**PHX SKY TRAIN
STAGE 2 DESIGN
500 S 24TH STREET
PHOENIX, AZ 85034**

**RCC STATION
STRUCTURAL
STANDARD FRAMING SECTIONS AND
DETAILS**

RCC STATION

**RCC STATION
SITE PLAN
COMMUNICATIONS
LEVEL 1 - GROUND
AREA A AND AREA D**

B04 - RBME010

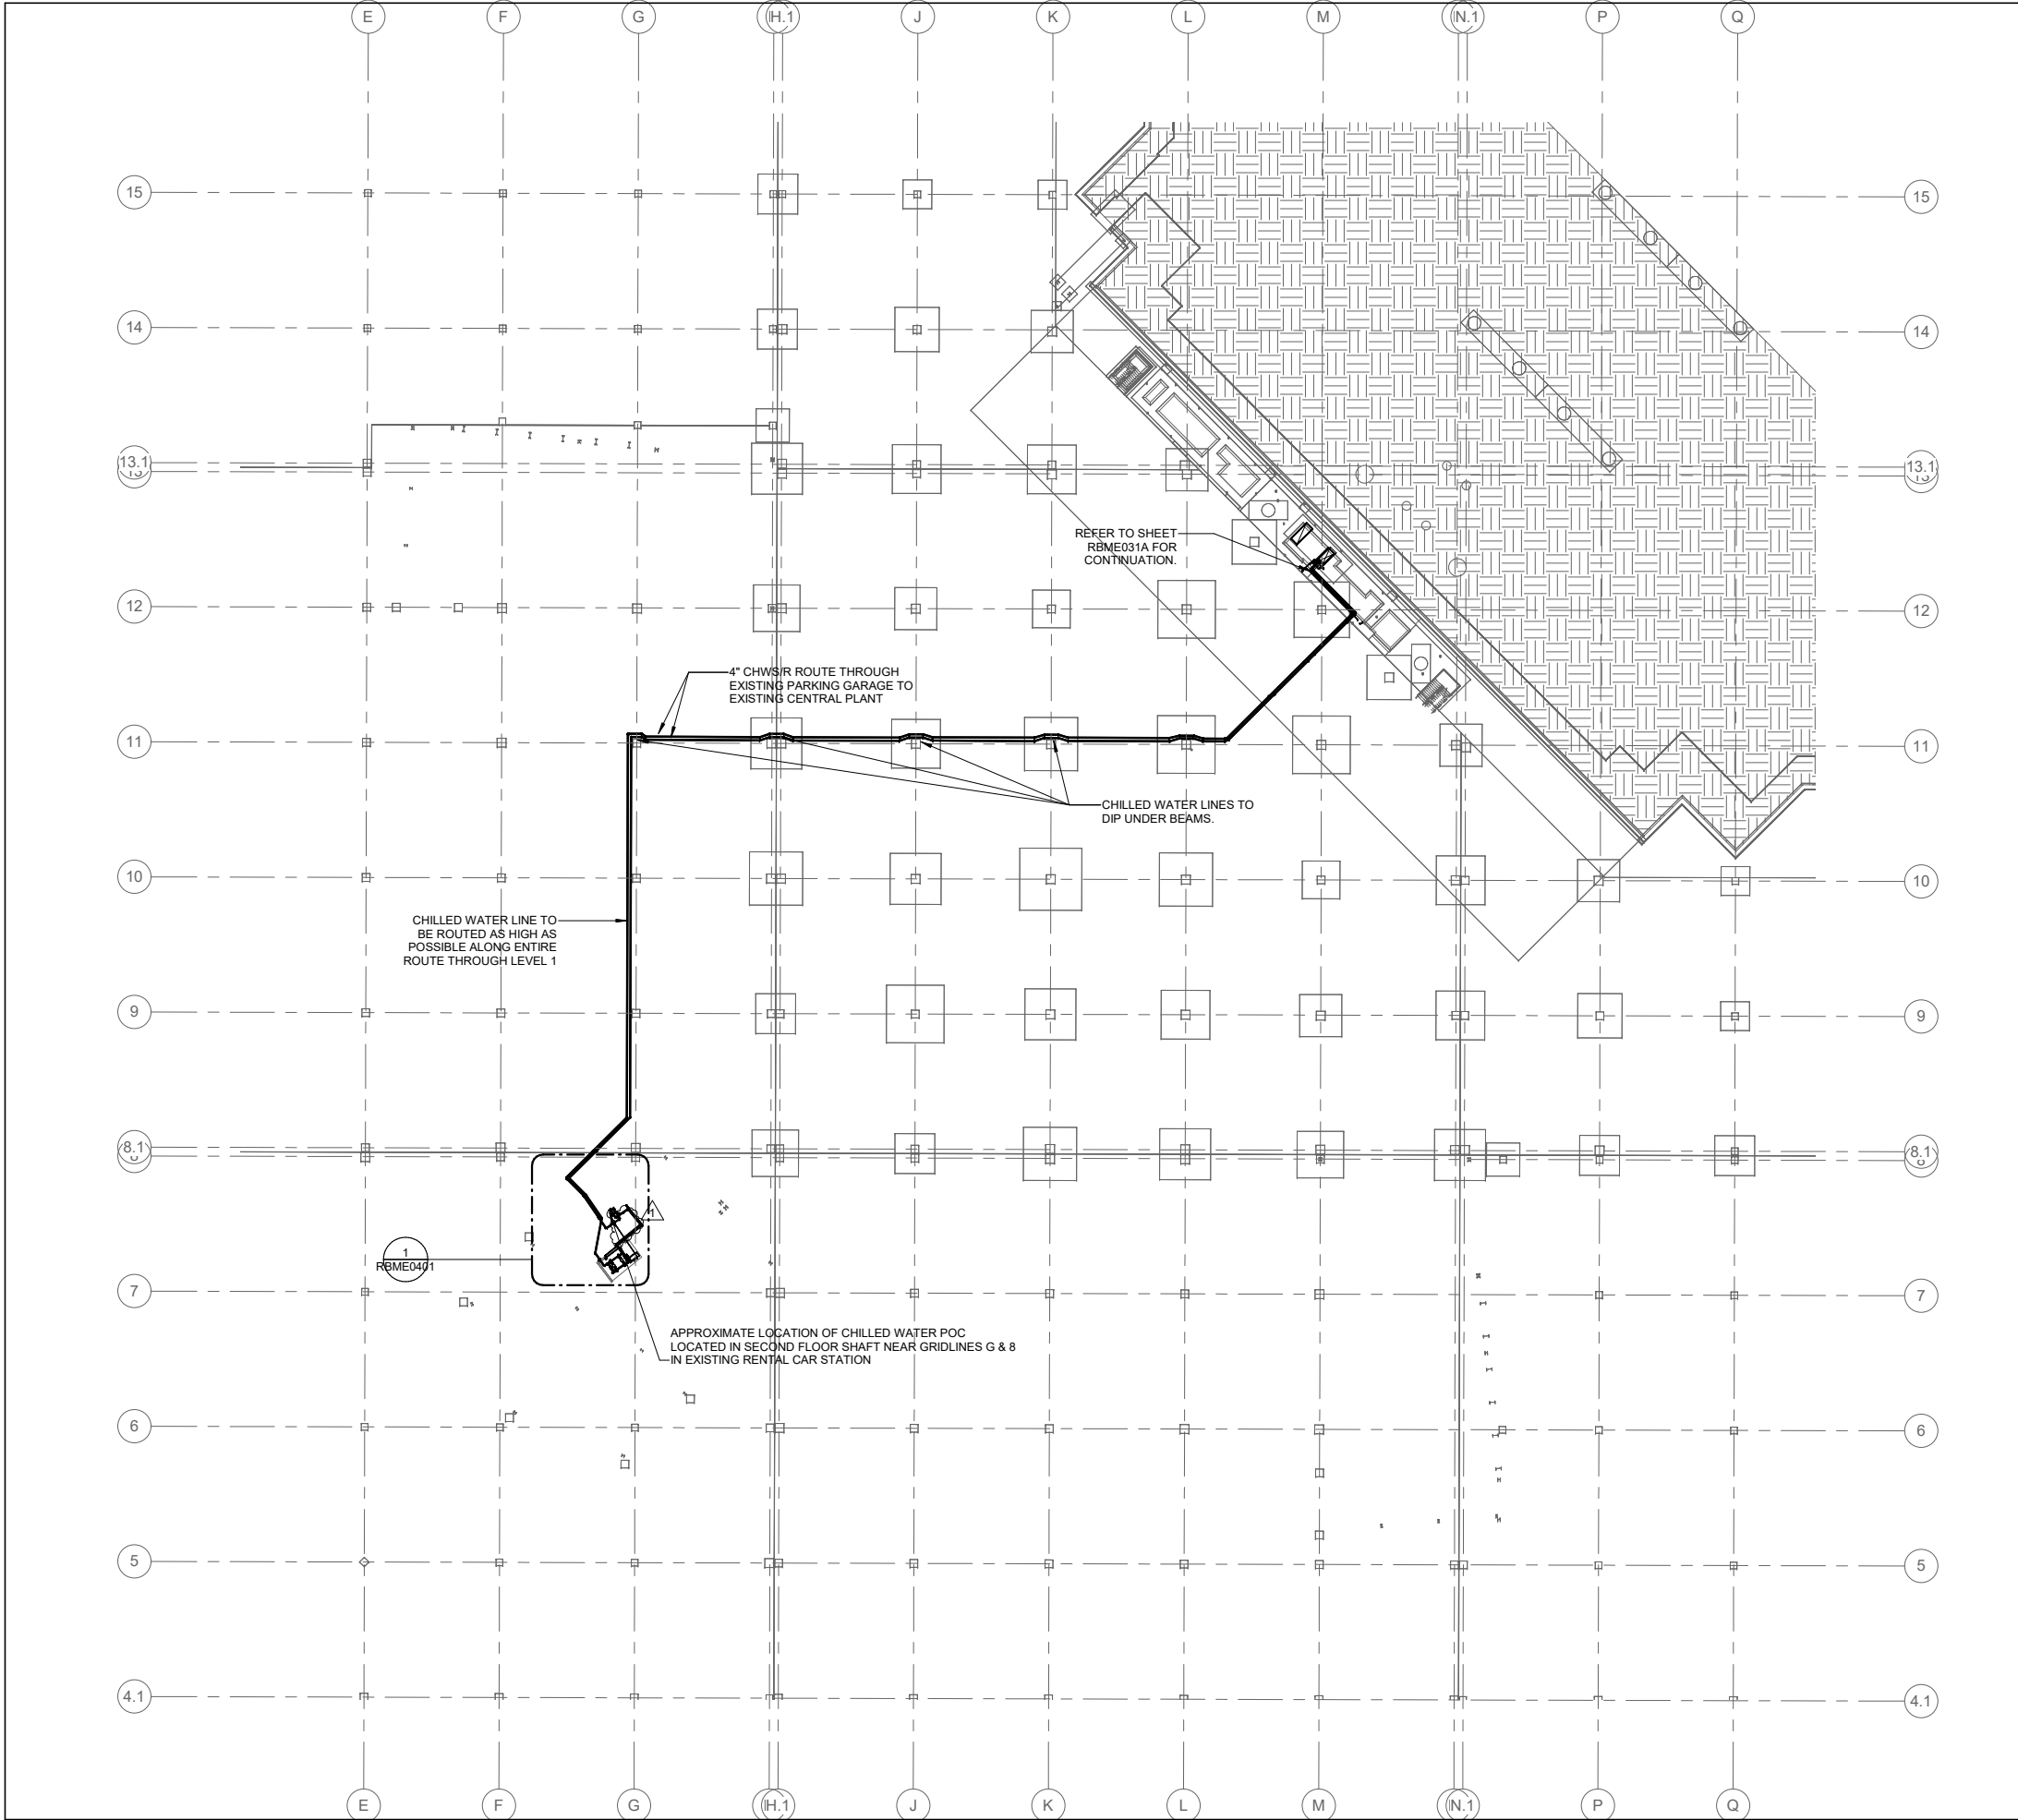
no expansion joints required for chilled water pipe, groove couplings sufficient for expansion per RFI 1808

Package: **B04 - RBCO031A** Sheet Reference No:

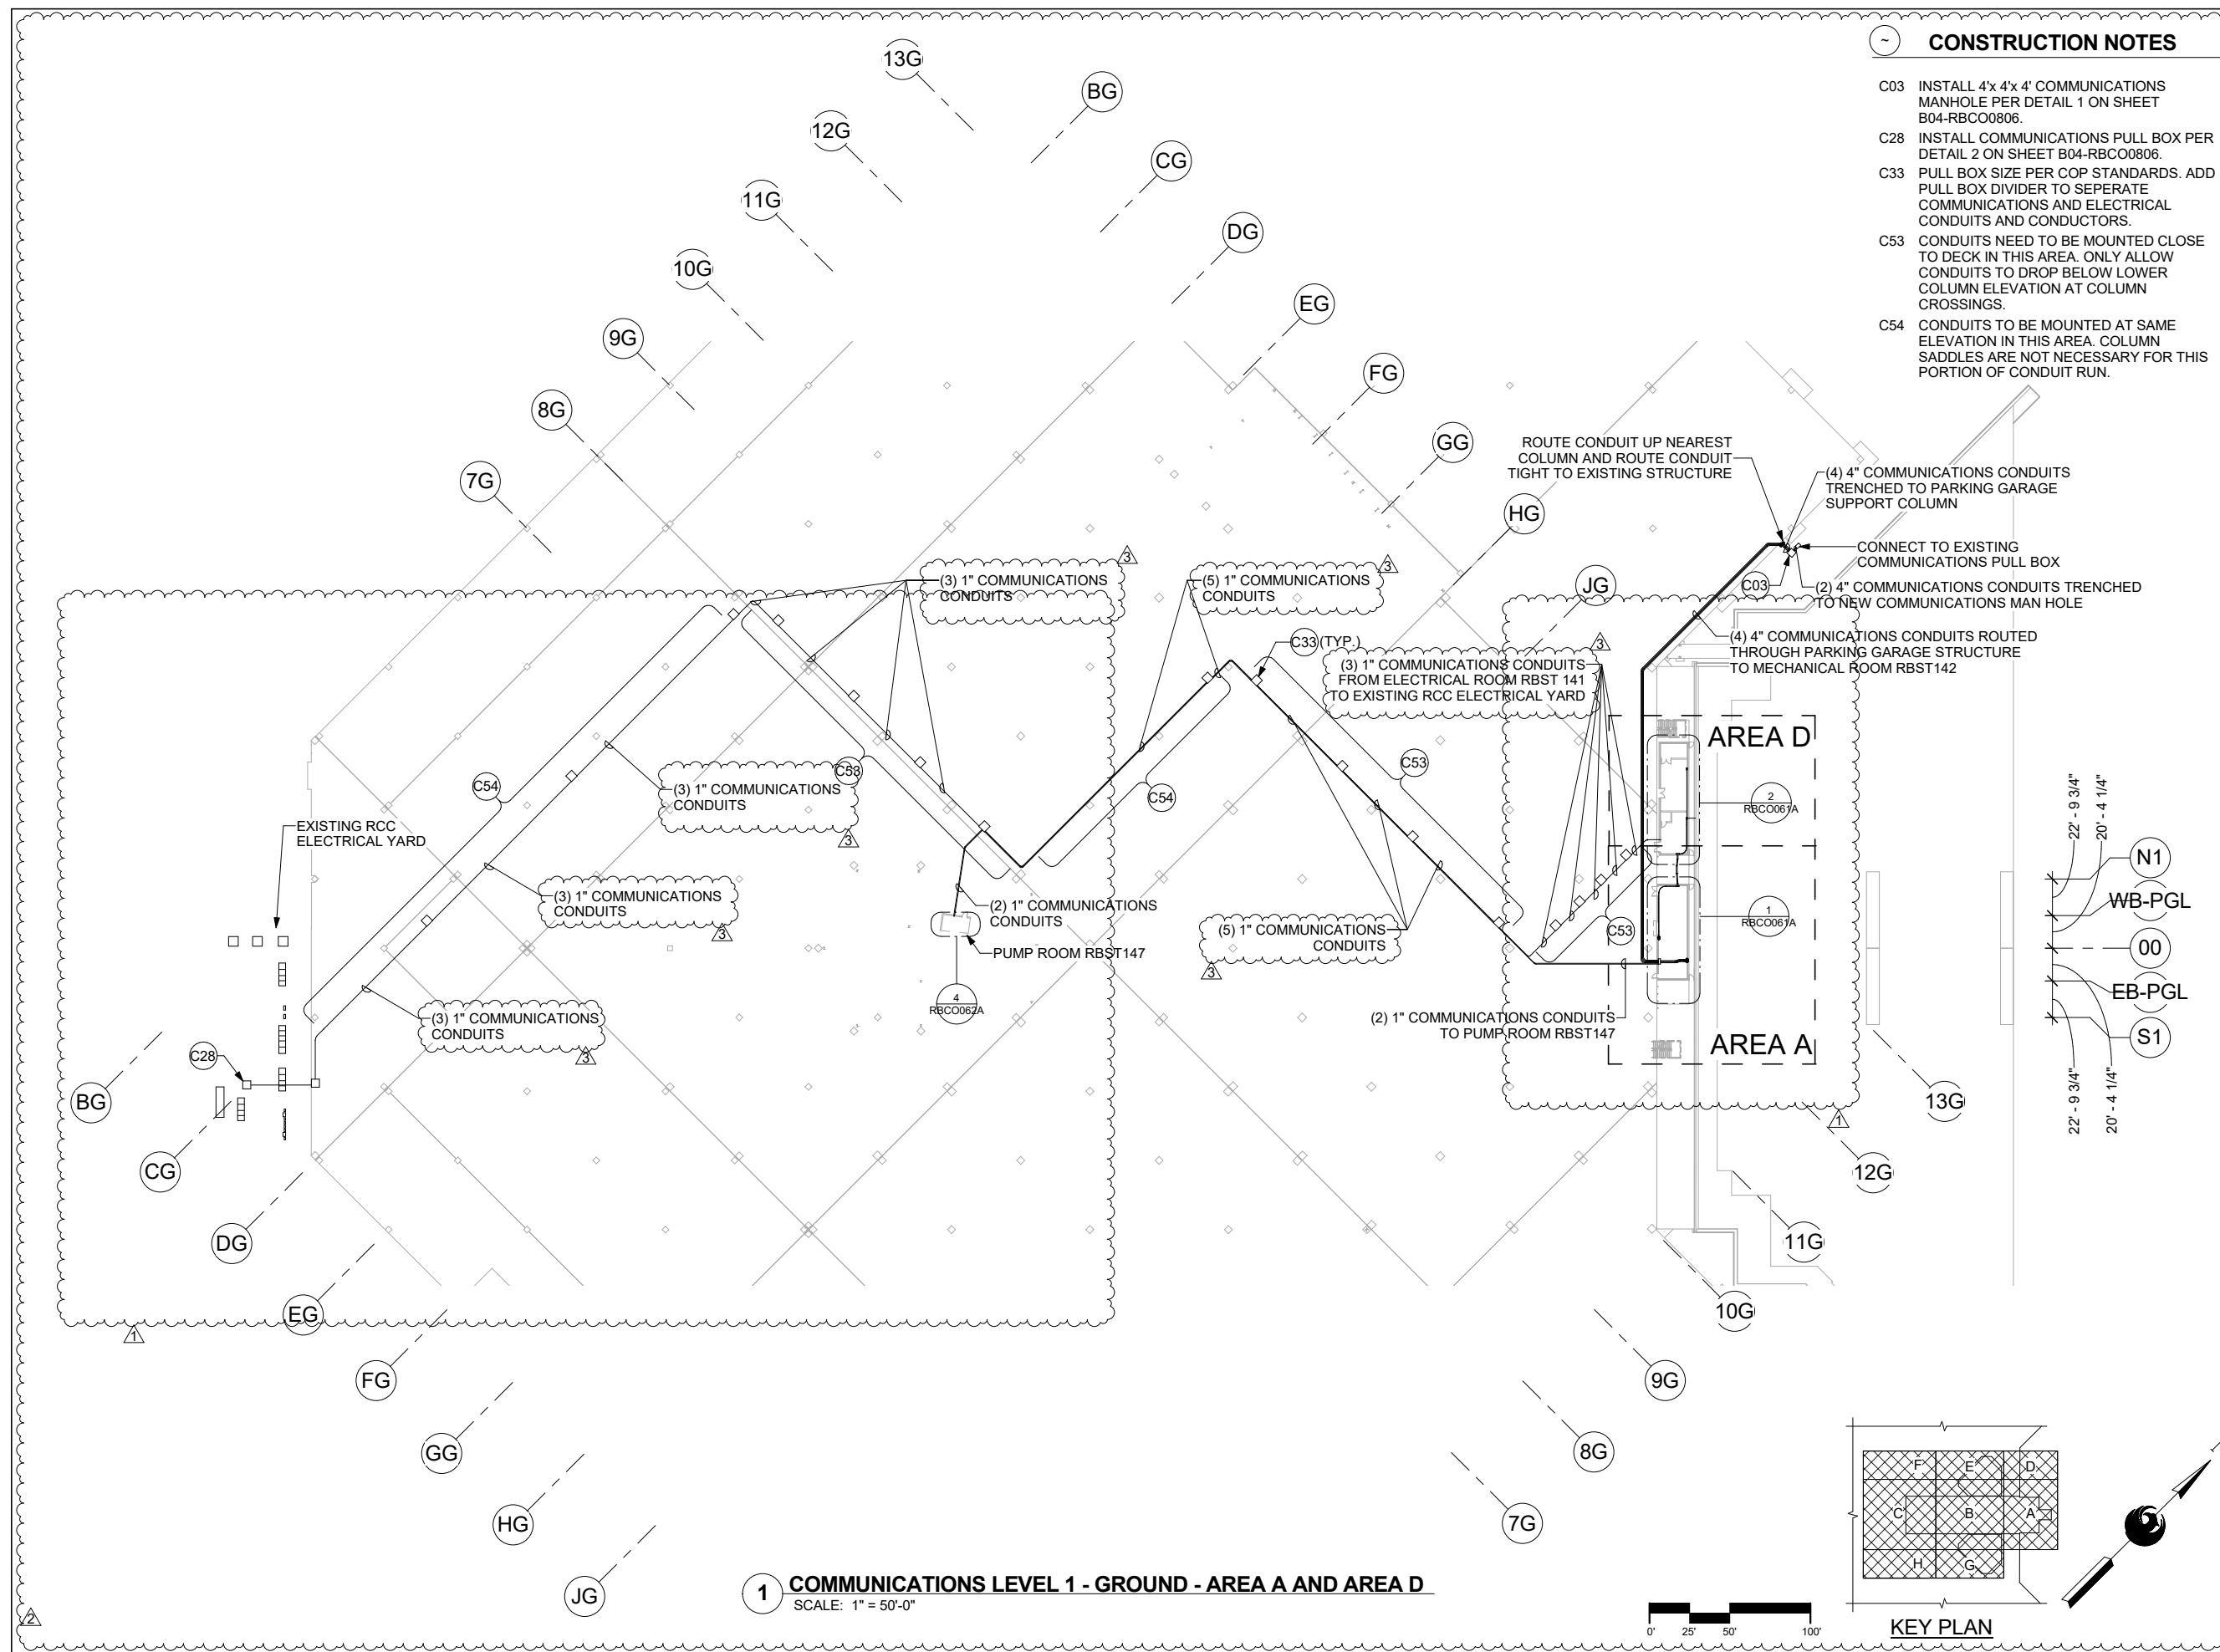
- C03 INSTALL 4'x 4'x 4' COMMUNICATIONS MANHOLE PER DETAIL 1 ON SHEET B04-RBCO0806.
- C28 INSTALL COMMUNICATIONS PULL BOX PER DETAIL 2 ON SHEET B04-RBCO0806.
- C33 PULL BOX SIZE PER COP STANDARDS. ADD PULL BOX DIVIDER TO SEPERATE COMMUNICATIONS AND ELECTRICAL CONDUITS AND CONDUCTORS.
- C53 CONDUITS NEED TO BE MOUNTED CLOSE TO DECK IN THIS AREA. ONLY ALLOW CONDUITS TO DROP BELOW LOWER COLUMN ELEVATION AT COLUMN CROSSINGS.
- C54 CONDUITS TO BE MOUNTED AT SAME ELEVATION IN THIS AREA. COLUMN SADDLES ARE NOT NECESSARY FOR THIS PORTION OF CONDUIT RUN.
